Title OMC Piezo Driver Overview		LIGO Laboratory California Institute of Technology Massachusetts Institute of Technology		LIGO	
Size: B	DCC Number: D060283	Revision: B2	Engineer: R. Abbott	Date: 9/26/2008	Time: 12:24:03 PM
File: C:\Rich's Files\Mycadfiles\ISC\DC_readout\PiezoDriver\OMC_overview_b.SchDoc					Sheet 1 of 4

D060283 Rev. B Piezo Driver SN [Redacted]

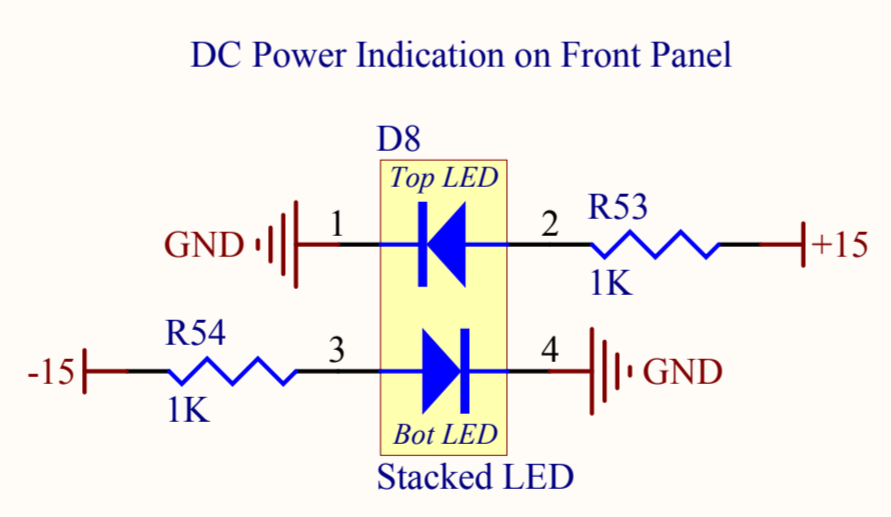
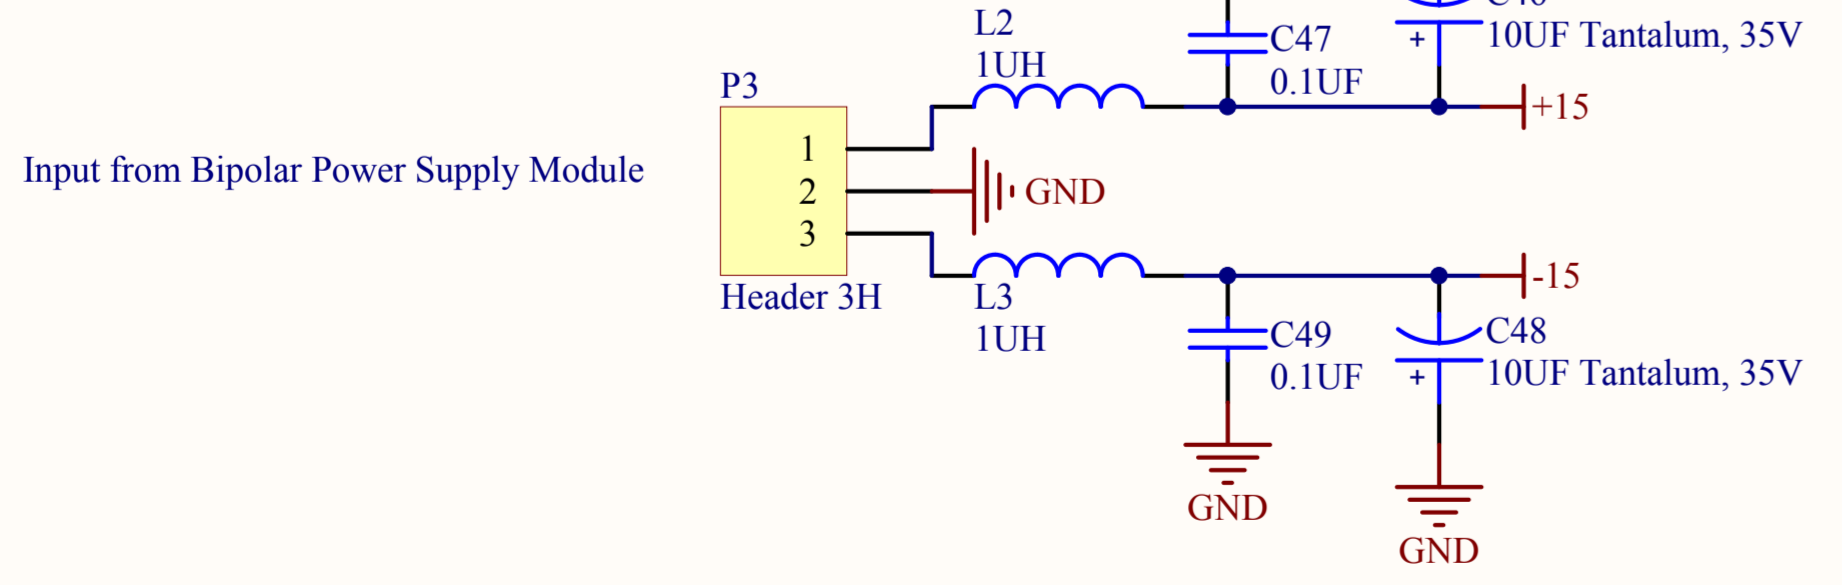
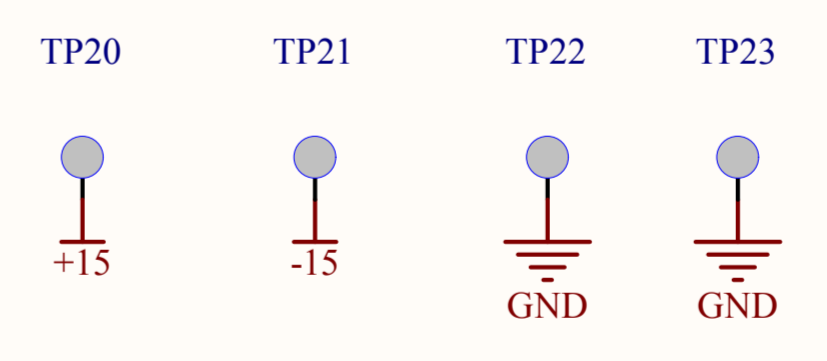
D8 Footprint is incorrect as shown, must be fixed on next revision

Revision History:
 Rev. A: Initial release
 Rev. B: Correction of footprint error from Rev. A
 Rev B1: Changed R22 from 100k to 200k
 Added 1k in feedback of unity gain follower stage, U16 in sheet 3 of 4. This was to correct abnormal noise performance in this opamp
 Rev B2: Changed R55 from 49.9K to 10K for more signal amplification. Changed R36 from 1K to OMIT as it is not needed.
MUST FIX D8 IF BOARD IS REVISED

Title		LIGO Laboratory California Institute of Technology Massachusetts Institute of Technology		LIGO	
Size: B	DCC Number: D060283	Revision: B2	Engineer: R. Abbott	Date: 9/26/2008	Time: 12:24:04 PM
File: C:\Rich's Files\MyCADfiles\ISC\DC_readout\PiezoDriver\HV_driver_b.SchDoc			Sheet 3 of 4

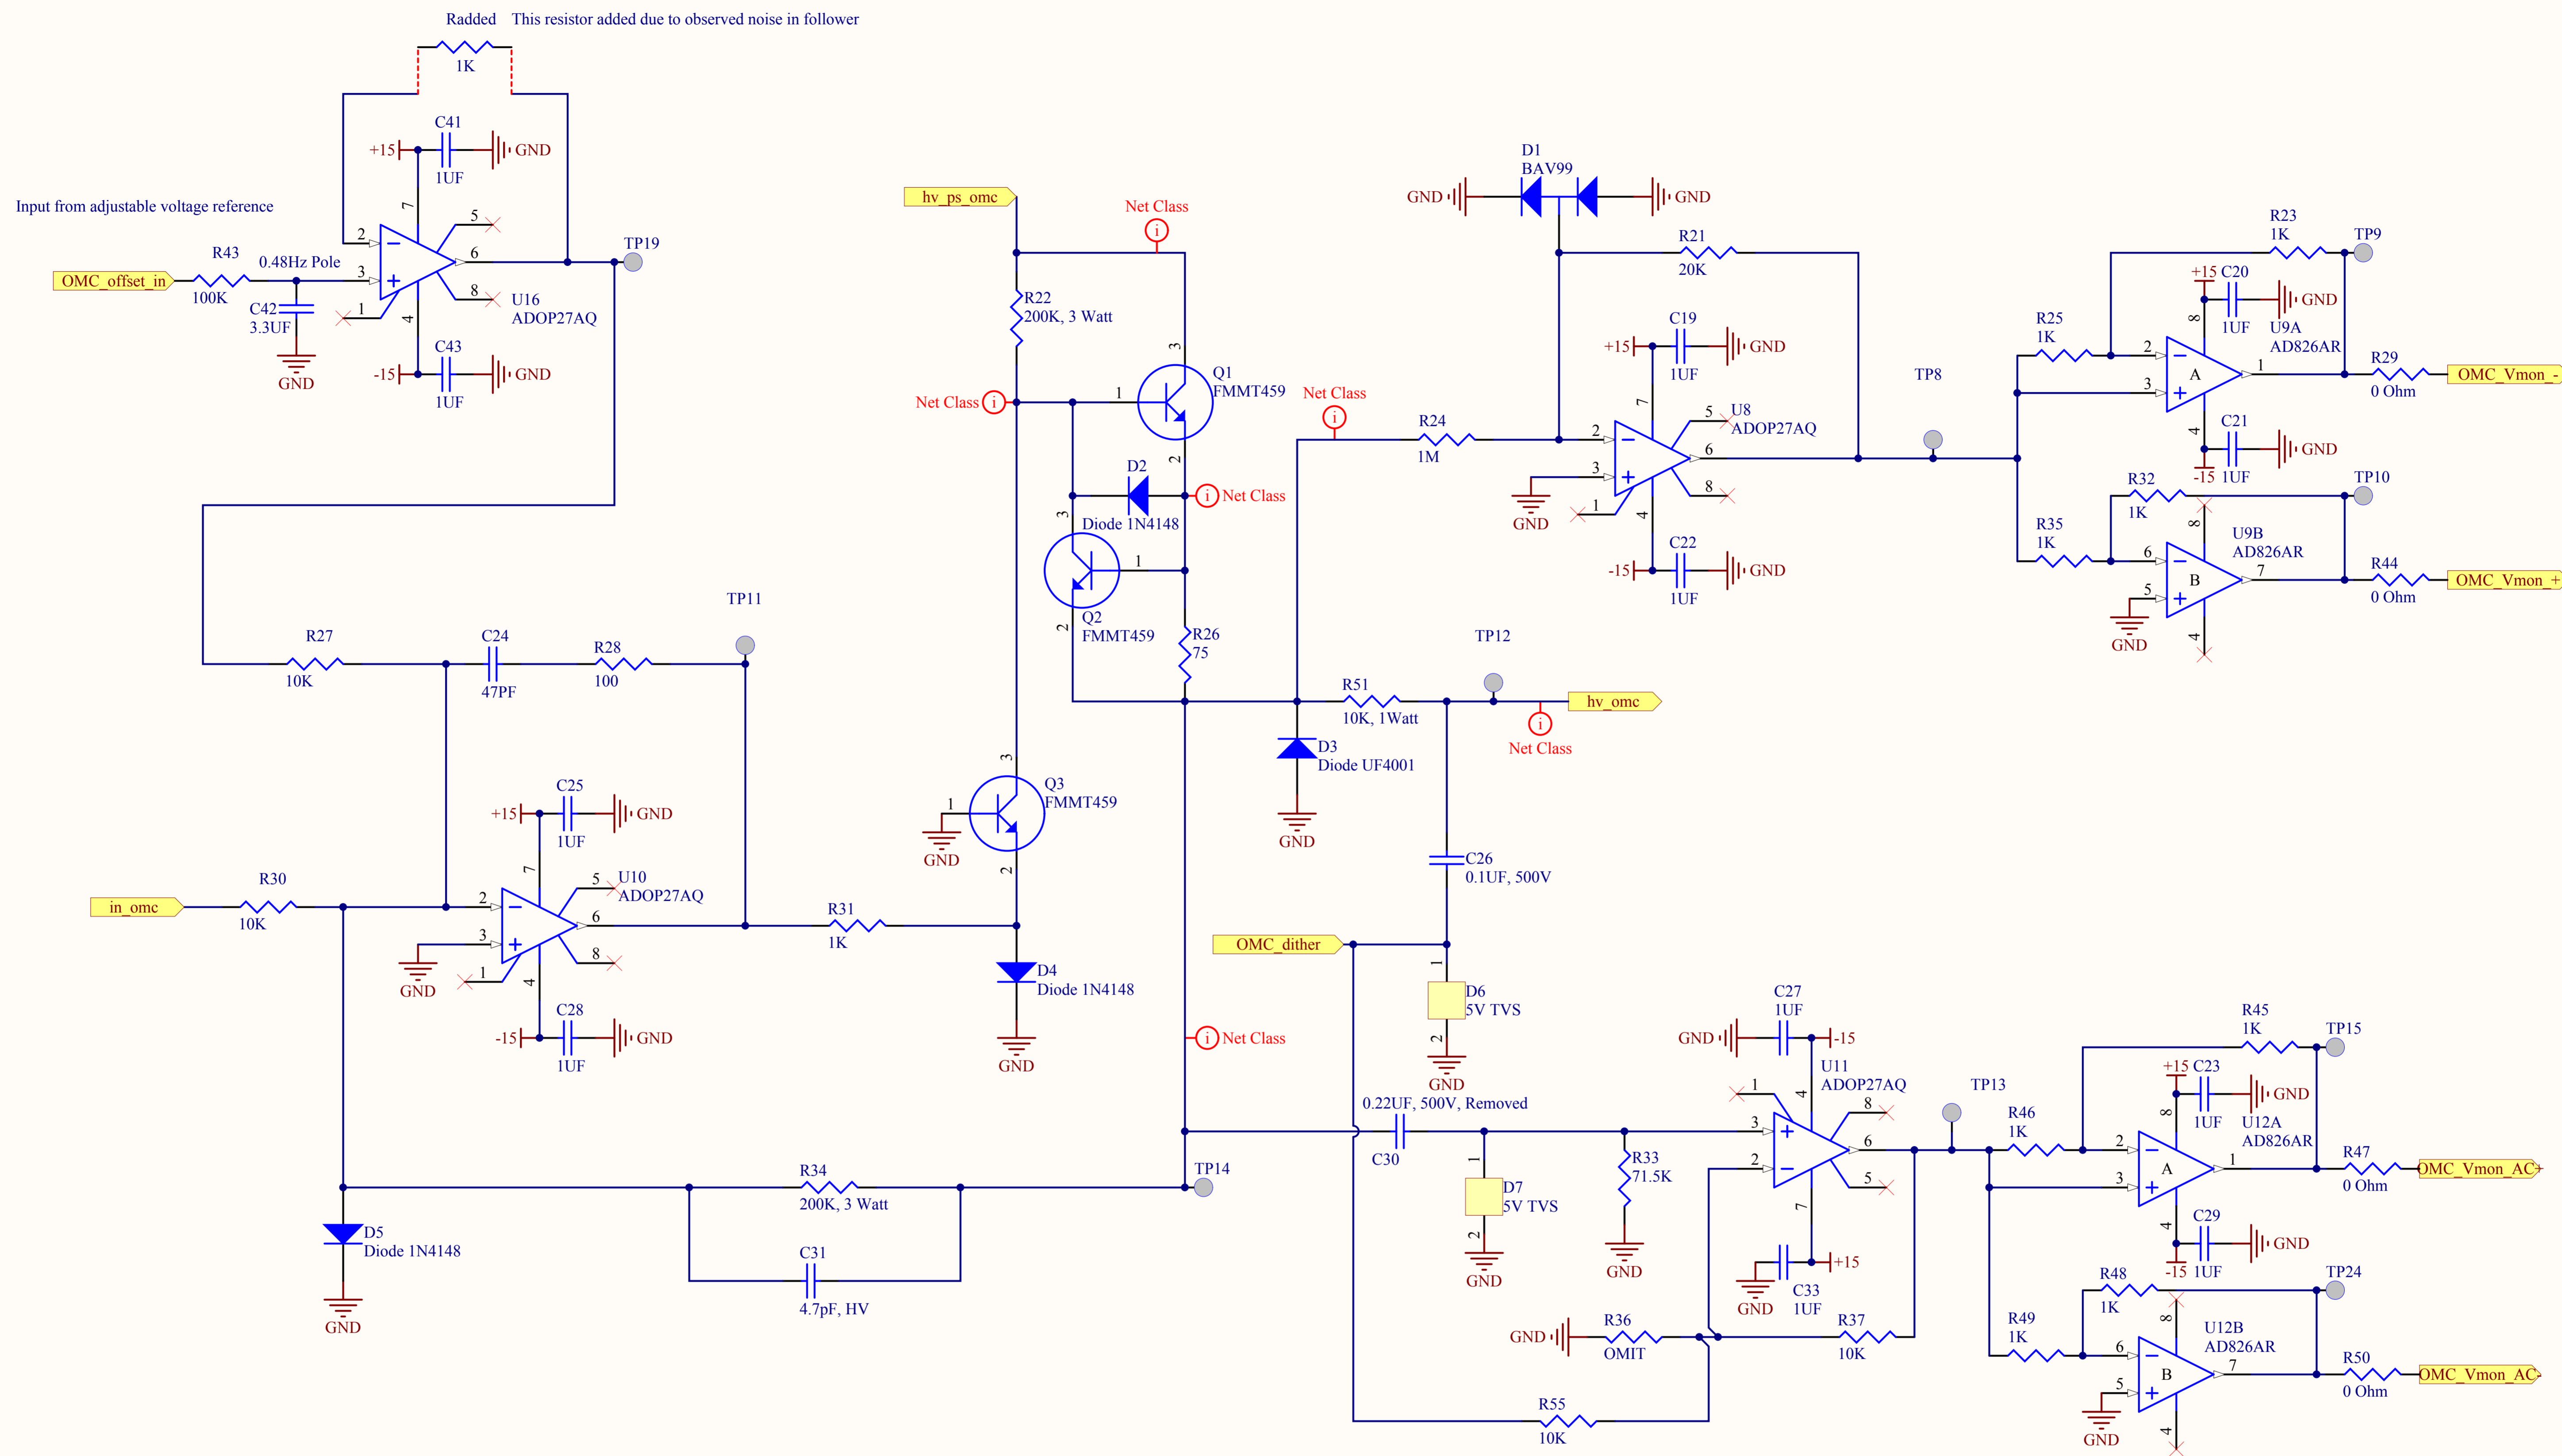
Radded This resistor added due to observed noise in follower
